HISTORIC AND DESIGN REVIEW COMMISSION

December 21, 2022

HDRC CASE NO: 2022-396
ADDRESS: 206 LAVACA ST
LEGAL DESCRIPTION: NCB 713 BLK 10 LOT 10
ZONING: RM-4, H
CITY COUNCIL DIST.: 1
DISTRICT: Lavaca Historic District
APPLICANT: Sam Xu/Lake Flato Architects
OWNER: URBAN CREATIVE LLC HILL
TYPE OF WORK: Front façade modification
APPLICATION RECEIVED: December 09, 2022
60-DAY REVIEW: Not applicable due to City Council Emergency Orders
CASE MANAGER: Rachel Rettaliata

The applicant is requesting a Certificate of Appropriateness for approval to remove the stucco cladding from the front façade.

1 EAST ELEVATION
A1 1/4" = 1'-0"

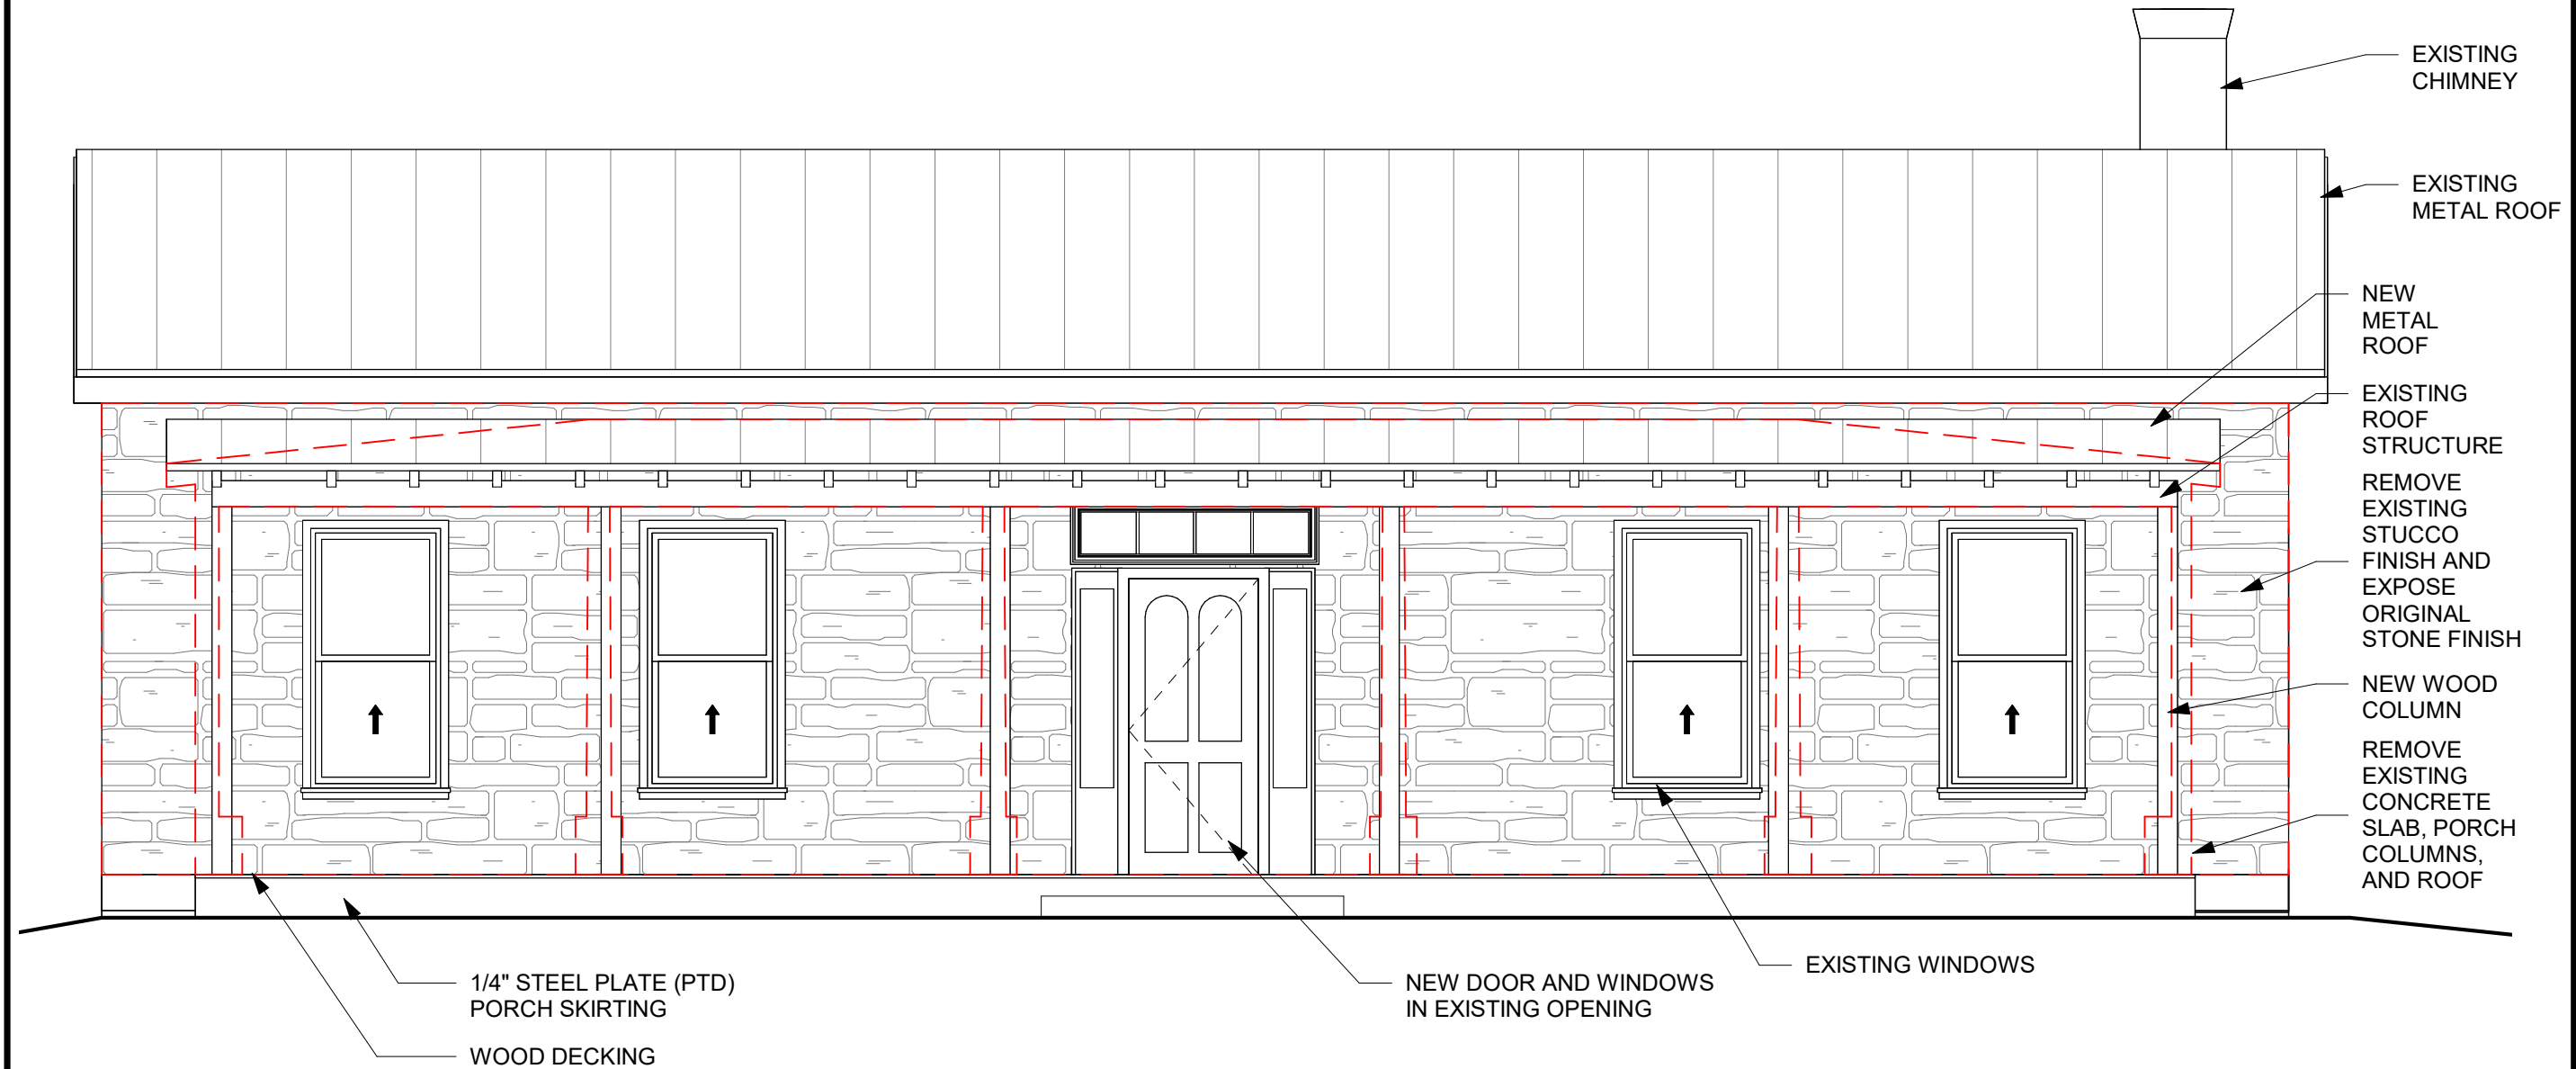
- c. **STUCCO CLADDING REMOVAL** – The applicant has proposed to remove the existing stucco cladding from the front façade to expose the stone construction. According to the 1904 Sanborn map, the structure is constructed of adobe (caliche block) and likely featured a stucco coating at the time of construction. Guideline 2.B.iv for Exterior Maintenance and Alterations states that stucco should only be removed from masonry surfaces where it is historically inappropriate. The applicant has submitted evidence that the existing stucco façade treatment likely dates to the 1950s; however, adobe structures traditionally featured a sacrificial coating, such as cement stucco, which came into use as an adobe surface coating in the early 20th century, to protect the adobe. The existing stucco façade treatment was in all likelihood applied to replace a previously existing surface coating. Staff finds that the façade would have historically featured a stucco treatment in a similar presentation as existing and that full removal would not be appropriate or consistent with the Guidelines.

Staff does not recommend the approval of the removal of the stucco cladding from the front façade based on findings a through c. Staff recommends that the stucco and the appearance of the front façade not be altered.
